Re: **21/02639/FUL Land West of 75 Town Furze, Oxford OX3 7EW**

Erection of 2 x 4 bed dwelling houses (Use Class C3). Provision of amenity space, car parking and bin stores. Associated landscaping, boundary treatments and ancillary works.

**OBJECTION to this application from Friends of Lye Valley (FoLV) 03 Nov 2021**

**Fig. 1:** Dr Webb's sketch map of the combined surface and groundwater catchment areas<sup>2</sup>. **Black shading** indicates the north and south fen units of the Lye Valley SSSI. **Red markings** outline catchment limits for South Fen unit (centre: grid ref SP5502 0528).

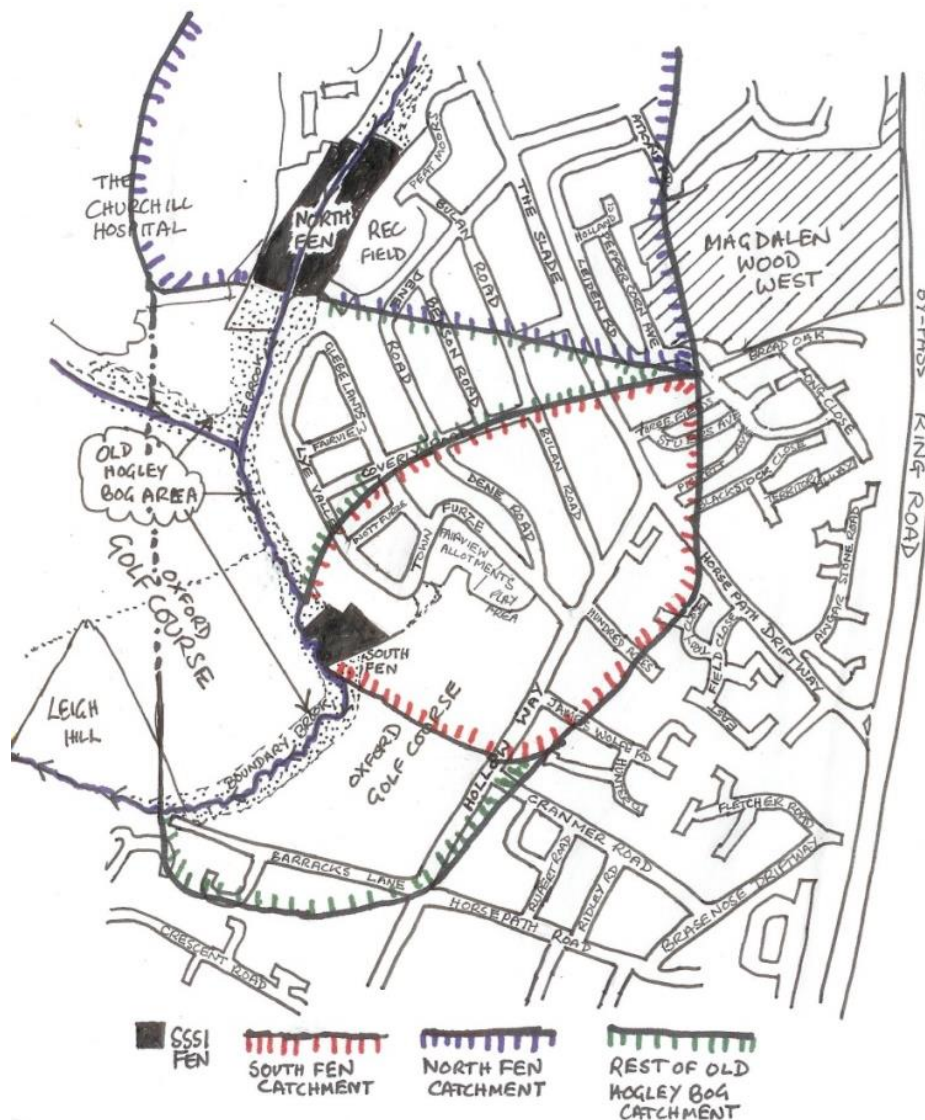
The calculated rainwater catchment of the SSSI has been available since 2007 in a report by expert hydrologist [Dr Curt Lamberth<sup>1</sup>](#), yet the Hydrological Assessment document for this application presents an entirely misleading representation of the fen catchment (Fig 9, p.15). The calculated catchment area given in that document of **2.842 km<sup>2</sup> is not an accurate representation of the water catchment of the south fen.**

The relevant rainwater catchment area for the south fen SSSI is indicated in the sketch below, drawn by **Dr Judy Webb**. The area of this specific, small and thus vulnerable, water catchment is **estimated by FoLV as approximately only 20.5ha**. About half of this catchment is now covered in urban development, **with a considerable impermeable area**. Consequently **the remaining green spaces within it are now critical water supply areas for the south fen**.

**Figure 2:**

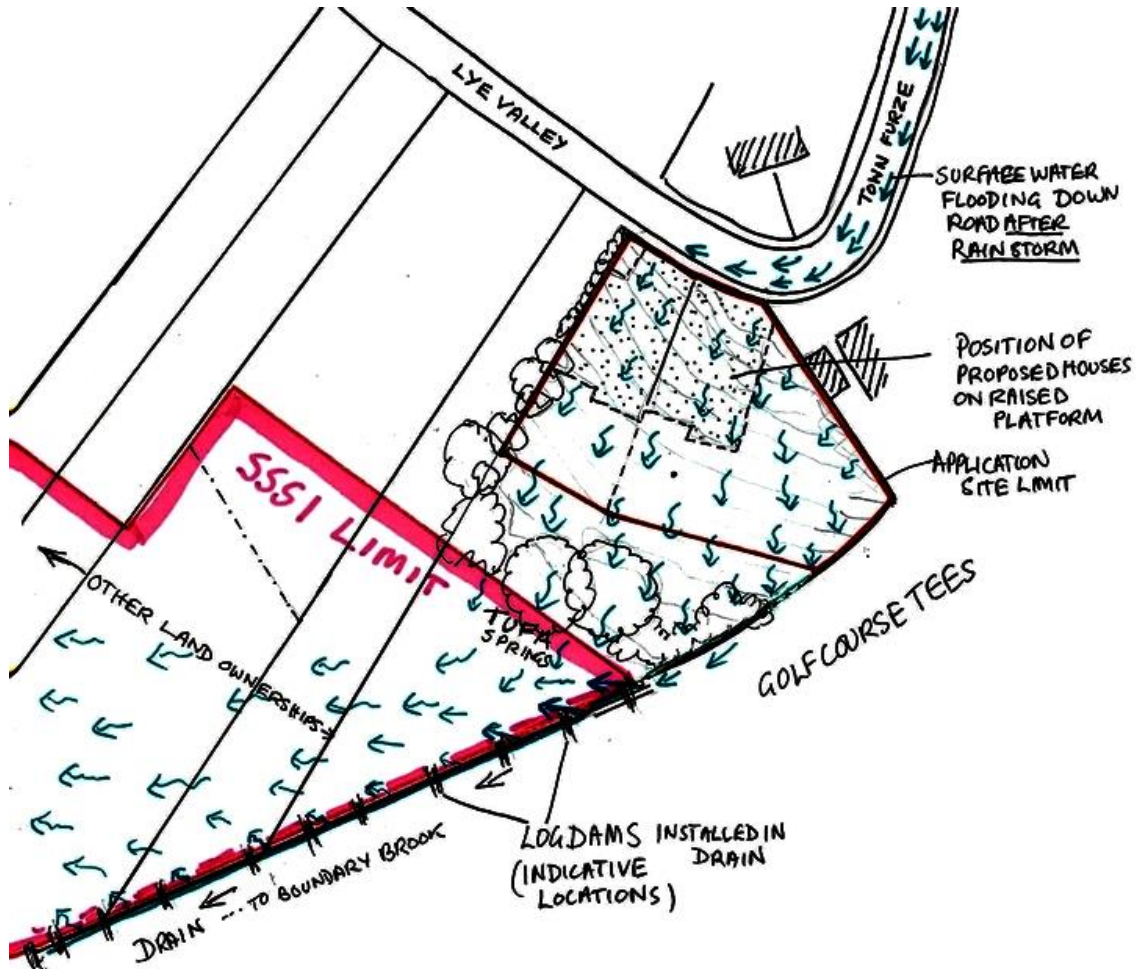
Rain water currently flowing over the sloping hillside surface of this site, or emerging as seepage zones on the south and east margins of the land ownership, is **intercepted and directed into a marginal drain**, which runs NE to SW. Previously this drain carried water **past** the south fen and **it was lost into the Boundary Brook**. However Natural England grant-funded a number of log dams in this ditch to stop this spring water leaving and it is **now directed onto the centre of the south fen**, achieving useful re-wetting, preventing summer drought drying the fen out, improving its habitat condition.

Sketch map to show application site in relation to South Fen SSSI limits and other landownerships. Green arrows indicate likely gentle surface water flow in the undeveloped situation. The faint, pale-grey, slightly wavy, lines approximate land contours.

- Note how surface and spring water flow from the applicant's land ownership is now redirected by log dams in the southern drain (installed 2016) into the centre of the south fen SSSI, achieving re-wetting.
- Note occasional surface water flooding down Town Furze Road.
